In the Drawings:

Please substitute Replacement Sheet 8 for original sheet 8, each containing Figures 19-21.

Remarks

FIG. 19

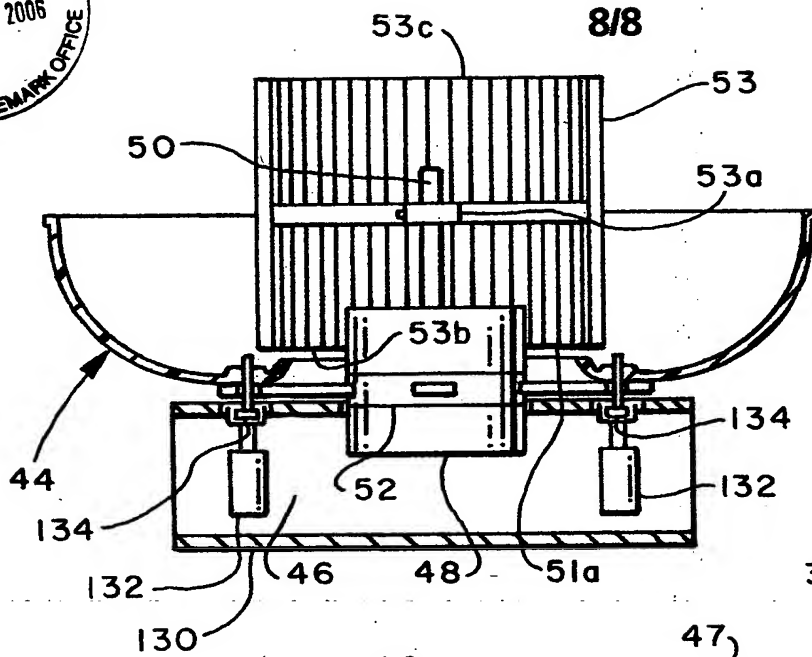
The drawings are objected to because the lead lines for reference numeral 48 in Figure 19 does not extend to the feature indicated and because the following reference characters are not mentioned in the description: 51A of Figure 19 and 55 of Figures 20 and 21.

Reference numeral 51A and related lead line and reference number 46 and related lead line have been removed from Figure 19 to address these objections (see annotated sheet and compare to replacement sheet).
